November 14, 1986

Docket Nos. 50-282
and 50-306

PRAIRIE ISLAND NUCLEAR GENERATING PLANT UNIT NO. 1

ATTACHMENT TO LICENSE AMENDMENT NOS. 80 AND 73
TO FACILITY OPERATING LICENSE NOS. DPR-42 AND DPR-60
DOCKET NOS. 50-282 AND 50-306

FIGURE TS.3.1-1

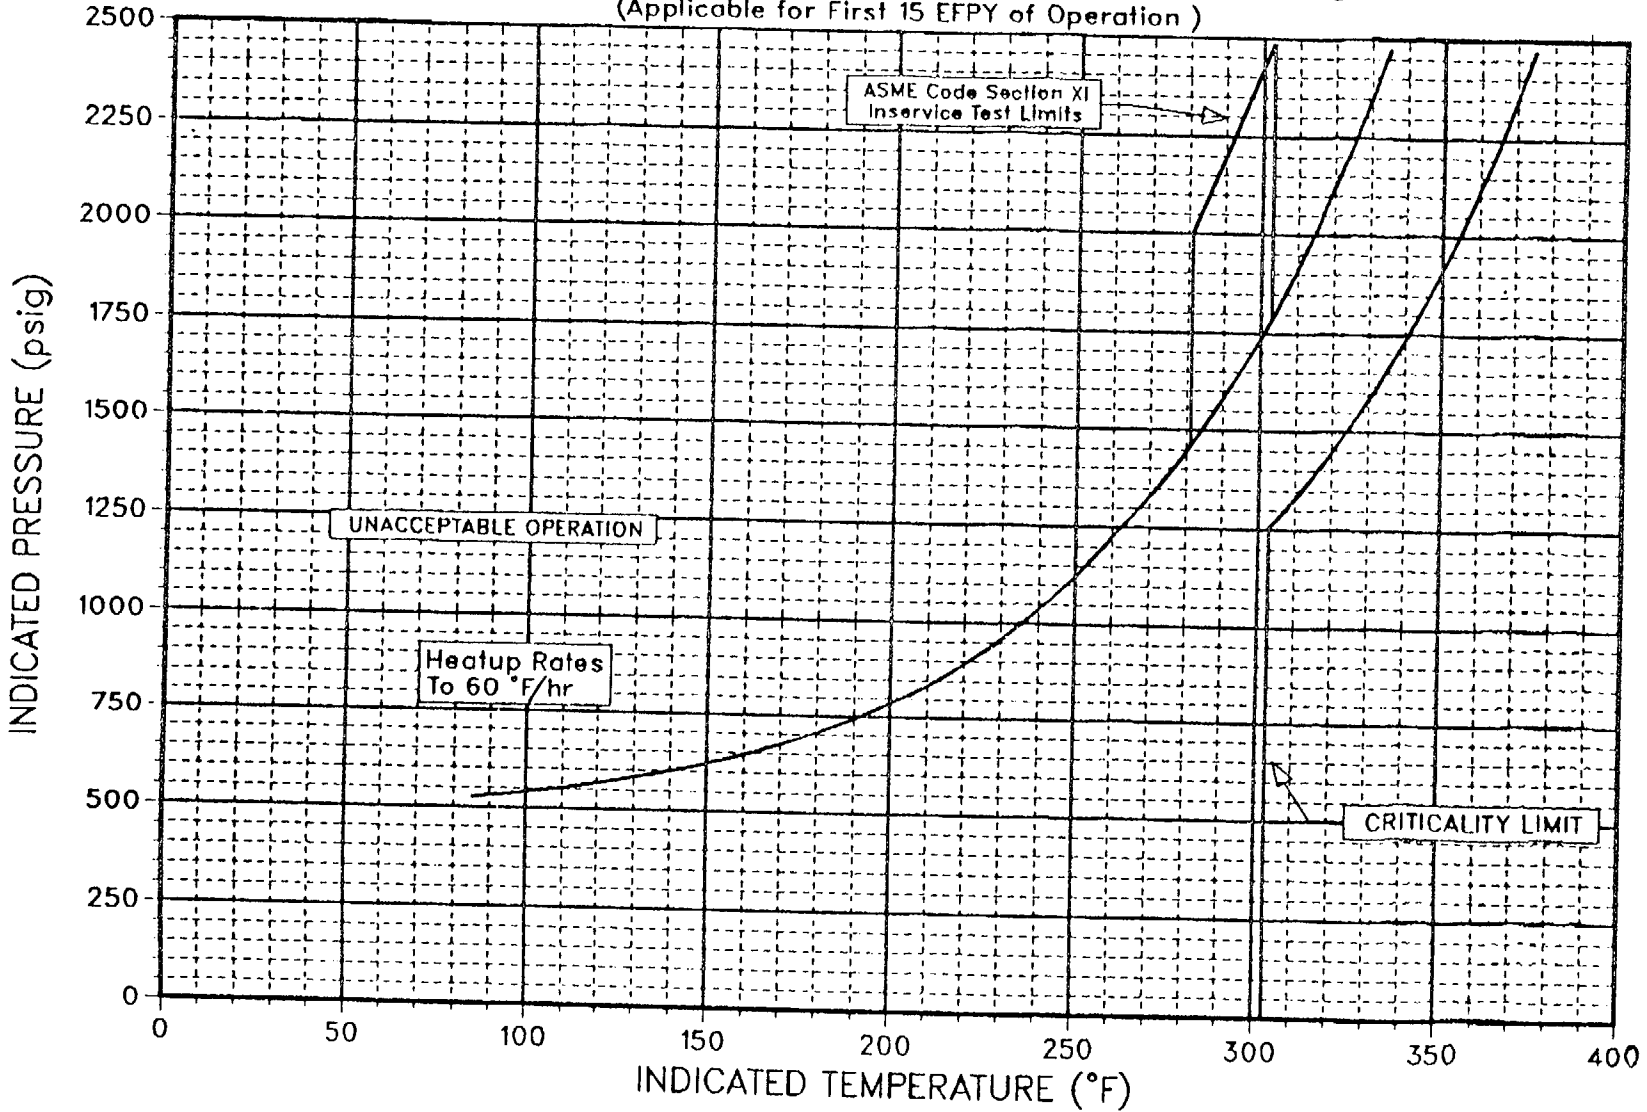
1. The Unit 1 and Unit 2 reactor coolant temperature and pressure and system heatup and cooldown rates (with the exception of the pressurizer) shall be limited in accordance with Figures TS.3.1-1 and TS.3.1-2.

UNIT 1 and UNIT 2
REACTOR COOLANT SYSTEM HEAT UP LIMITATIONS
(Applicable for First 15 EFPY of Operation)

FIGURE TS.3.1-2

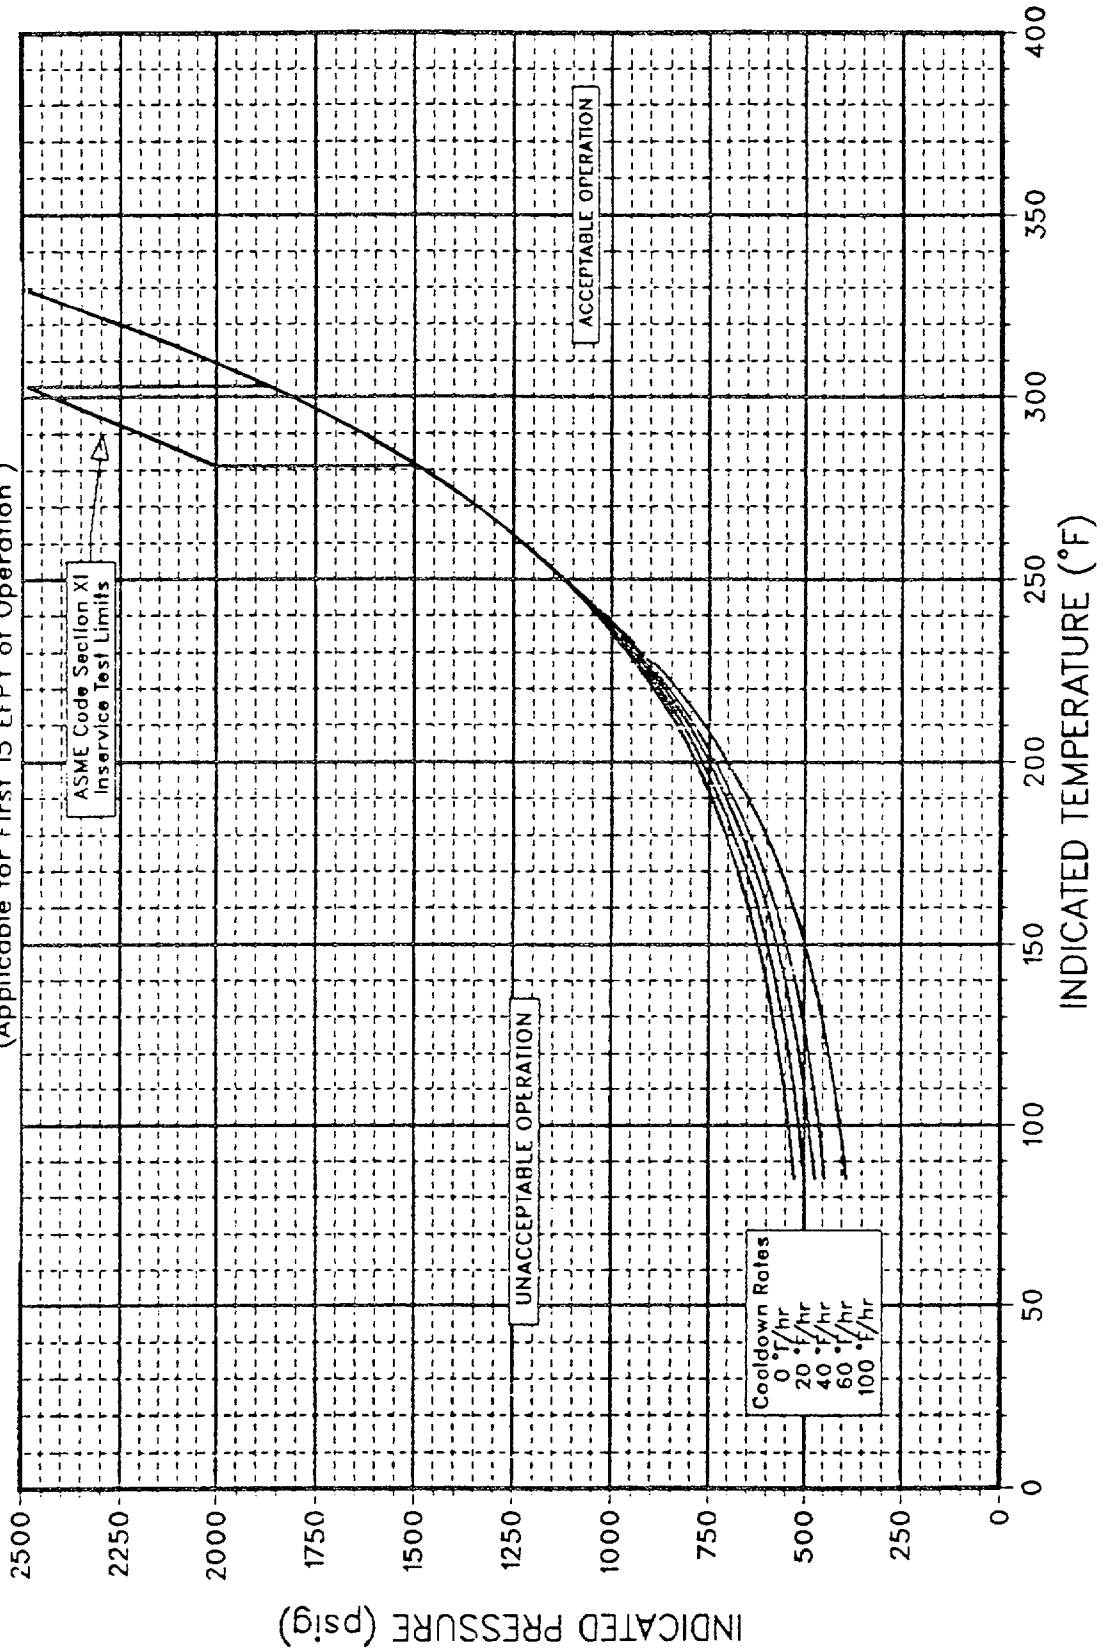
UNIT 1 and UNIT 2
REACTOR COOLANT SYSTEM COOLDOWN LIMITATIONS
(Applicable for First 15 EPY of Operation)
